TRANSMITTAL OF TENTH TAAG REPORT - JBC-33-84

TENTH REPORT
OF THE
Technical Assistance and Advisory Group (TAAG)

Three Mile Island Unit 2 (TMI-2)
For the Period August 1, 1984 to December 1, 1984

FIGURE 1
 FUEL CASK WITH A 3-TON
 MOVABLE SLEEVE TO UNLOAD FUEL
 CANISTER AT UP-ENDER

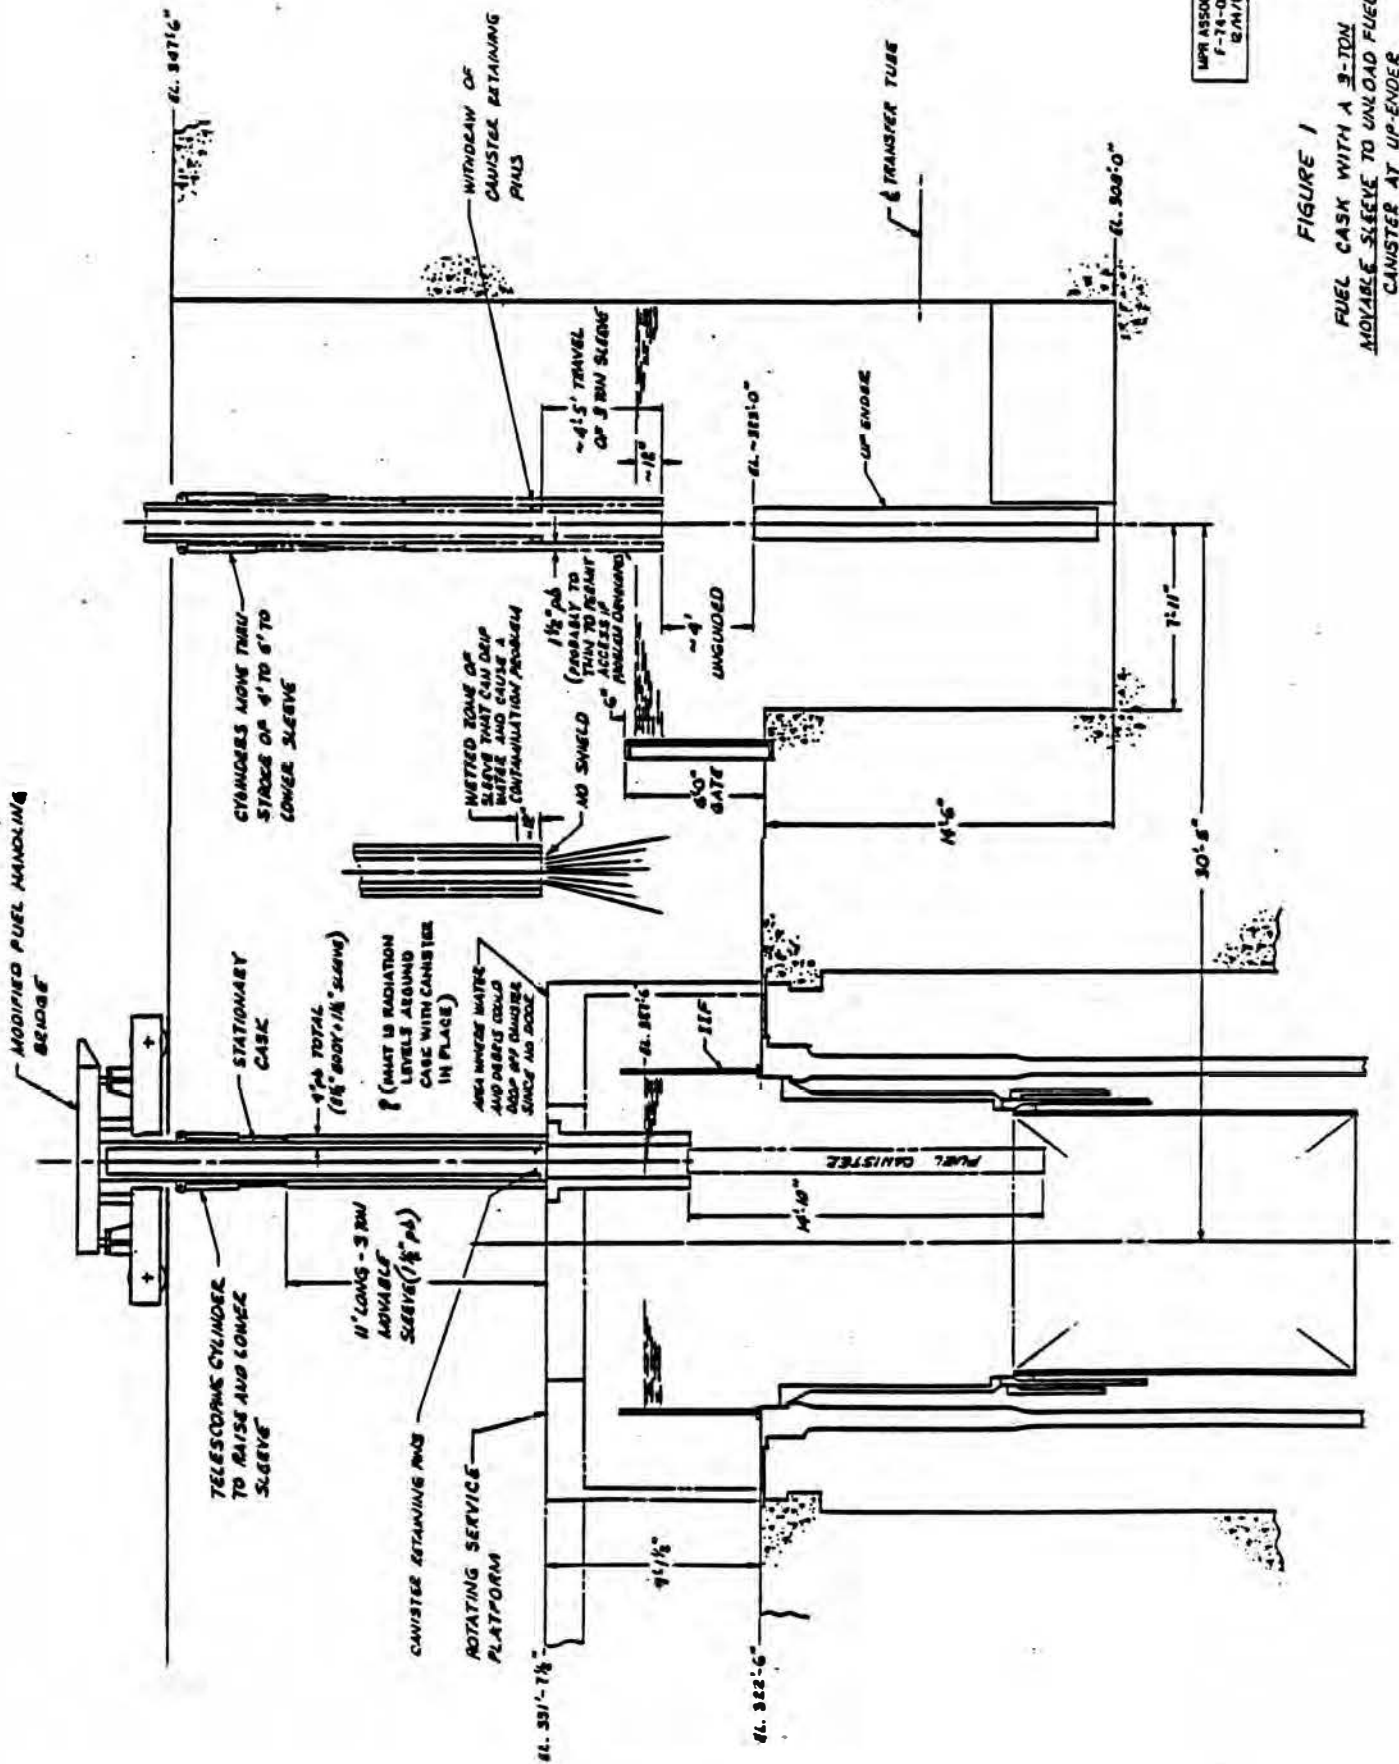
This proposed transfer cask has a movable three-ton shielded sleeve on the exterior diameter of the cask. This shielded sleeve moves through a stroke of about 4-5 feet by means of several telescoping hydraulic cylinders mounted near the top of the transfer cask (see Figure 1). It appears that one of the purposes for this movable sleeve is to allow the sleeve to be lowered while the cask's main body is held at a fixed elevation, thus providing some shielding down to the water level in the deep end of the refueling cavity as a fuel canister is lowered into the upending device. Our comments regarding this approach to the transfer cask are as follows:

Lowering the movable sleeve into the pool water for a foot or so for canister transfer means that part of the cask will be constantly wetted and dried and could be a source for tracking contamination across the top of the defueling service platform (see Figure 1). In this regard, it is suggested that consideration be given to going back to providing a static transfer boot over the upender. In such an arrangement the cask can be positioned on top of the transfer boot for canister discharge and the cask itself will not be wetted every time it discharges a fuel canister (see Figure 2). This use of a static shielded transfer boot to allow radioactive items to make the transition out of a cask into water has been used in many previous applications in the past. The reason for this approach is to avoid getting the exterior parts of the cask wet and having the contamination problems that can result from such wetting. Further, a single one-piece cask body and a static transfer boot eliminates the need for a three-ton movable sleeve with hydraulic cylinders and their associated control system for raising and lowering the lead sleeve. In essence, a static transfer boot, as shown in Figure 2, will result in a simpler and more inherently trouble-free tool for the TMI-2 defueling operation. This approach is consistent with previous experiences with this type of fuel handling operation, and avoids potential contamination problems due to wetting the exterior surfaces of the cask. It also avoids the probability of binding and hang-up of the telescoping sleeve mechanism.

1-1/2" of shielding will preclude getting people down into this area to work on the problem without first providing additional shielding in some manner. Accordingly, we recommend the use of a 6"-thick one-piece body for the cask and static transfer boot over the upender to allow immediate servicing if problems are encountered. The static transfer boot can also be fitted with a funnel-type guide to assure aligning the canister with the upender (see Figure 2). This approach should eliminate most of the potential problem areas pertaining to transfer cask radiation levels.

We note that the transfer cask is not provided with any type of door on its lower end. We recommend that a door be provided to ensure that as the transfer cask moves back and forth with canisters debris and/or water cannot fall out of the cask and onto the floor where it could present a potential contamination problem. The door should be shielded to avoid accidental high radiation exposures. As can be seen in Figure 1, there are some areas where personnel could be inadvertently subjected to a high dose of radiation during cask movement.

It is noted that the total shielding thickness of the transfer cask when it is on the rotating service platform is only 4" of lead (2-1/2" in the cask body proper and 1-1/2" in the movable sleeve - see Figure 1). It would appear this could result in a relatively high radiation level on the service platform and that steps would have to be taken to minimize having workers around the cask while it is loaded with a canister and/or limit workers on the rotating service platform during canister handling. We further note that another special cask is being designed for transferring fuel into the shielded rail shipping cask and it has 6" of lead shielding. It would appear to us that the 4" of lead on the transfer cask used in the reactor building is on the thin side and should be made thicker.

FIGURE 3

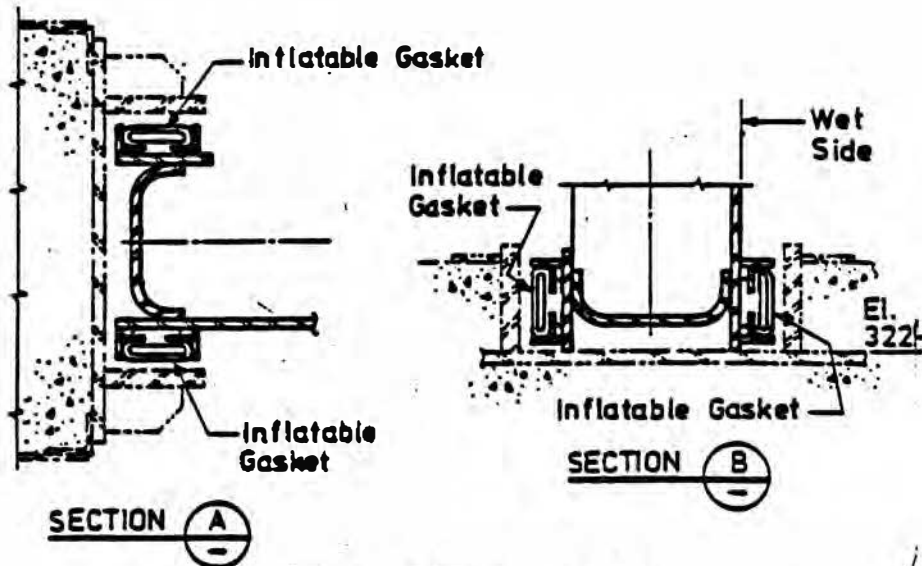
During the TAAG meeting a conceptual cross section of the refueling canal dam that is roughly 6 feet high was shown (see Figure 3). It includes two inflatable gaskets. However, the design of these two inflatable gaskets appears such that if either one fails, the other seal may also leak (e.g., when one seal leaks, the dam may move and cause the other seal to leak). Accordingly, we would suggest that the seal design configuration for the dam gasket be reassessed to ensure that if one gasket is lost, the dam will not move and cause the other gasket to leak. Specifically, we would recommend that this dam include at least one compression-type gasket seal which could be loaded by jack screws that mount off the dam body and act against the existing dam embedments in the canal walls.

FIGURE 4
-59-

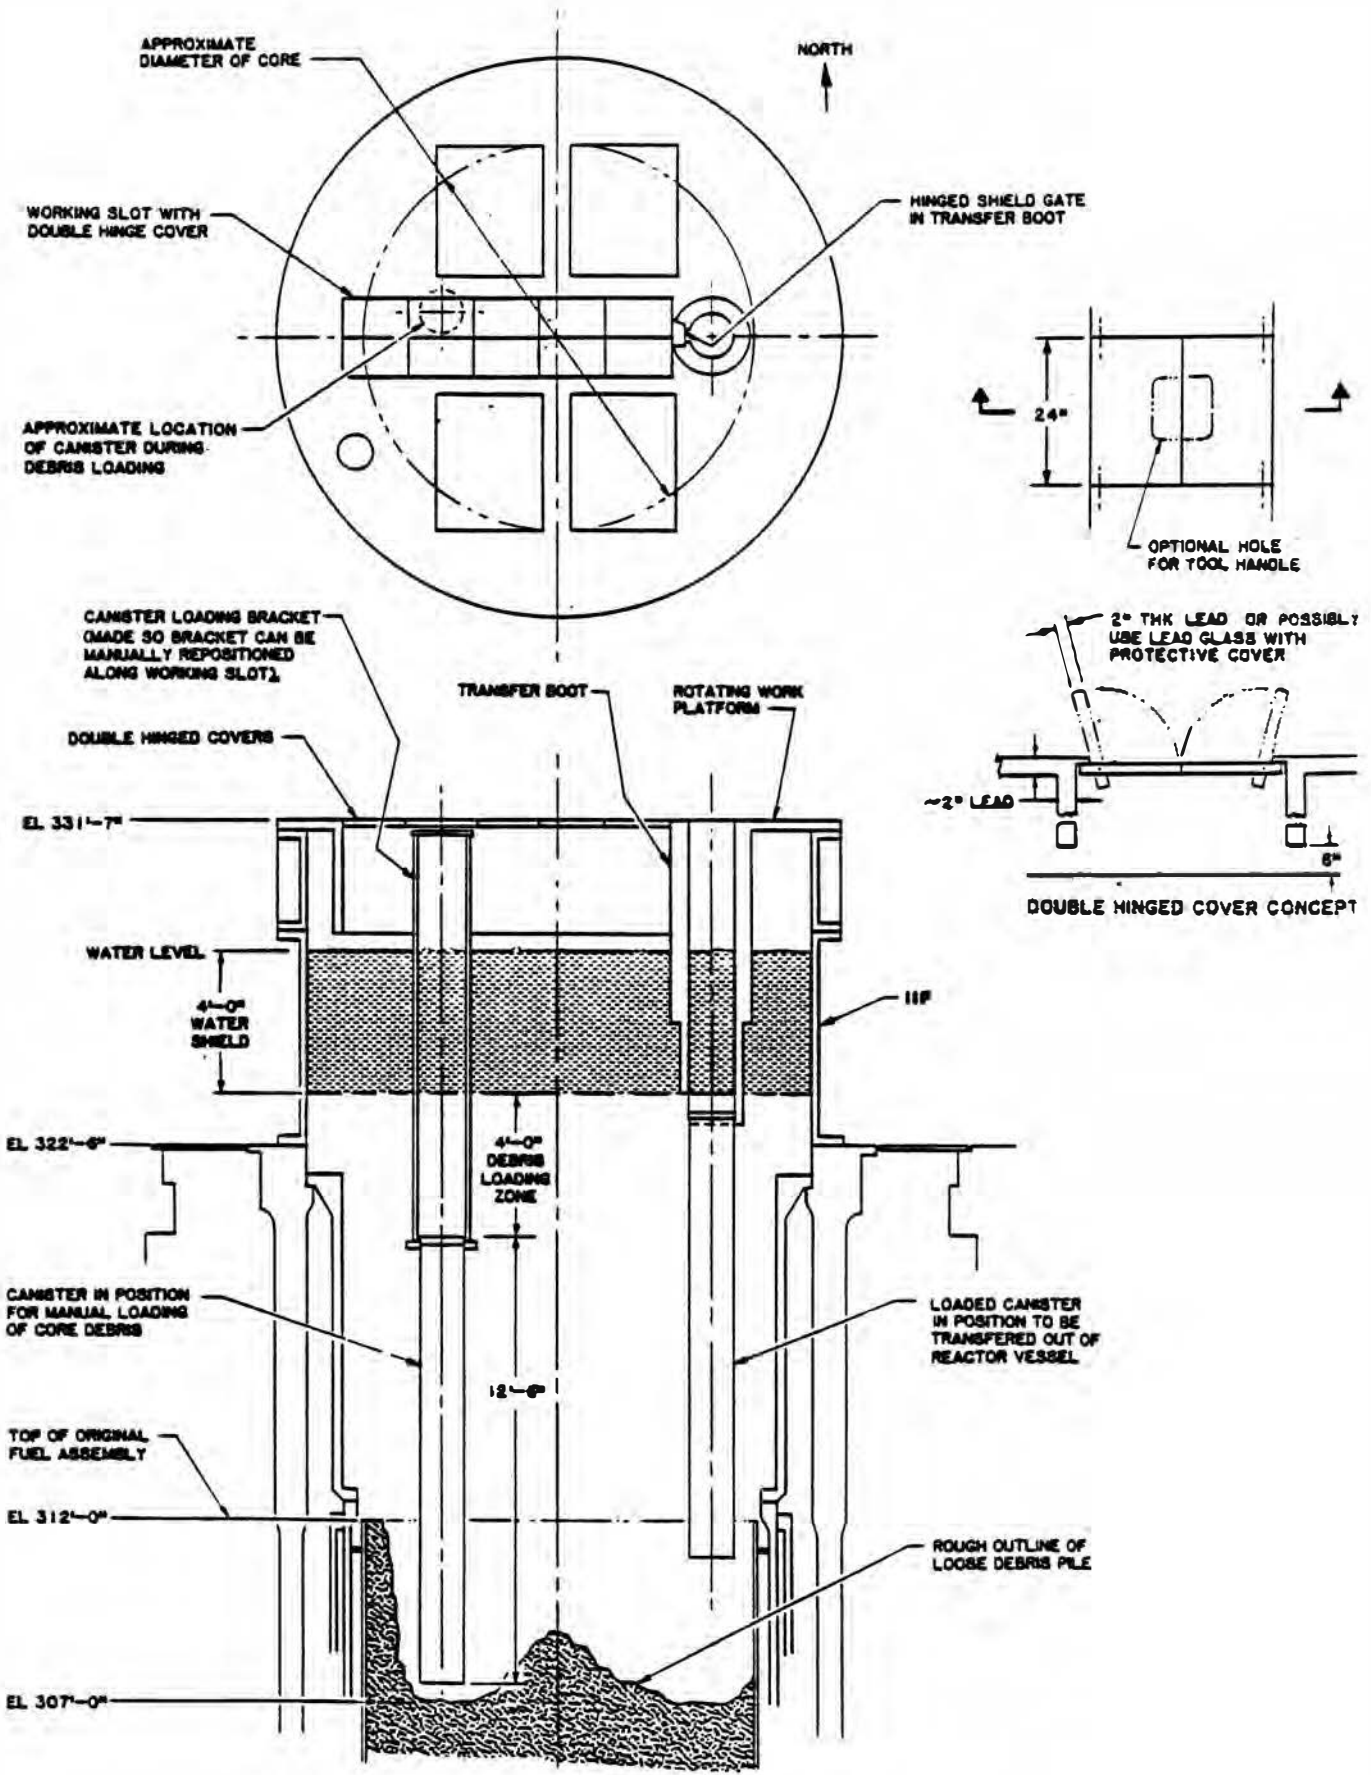
- (1) Provide a shielded transfer boot that projects from the work platform down several feet into the water to the canister transfer position (see Figure 4).
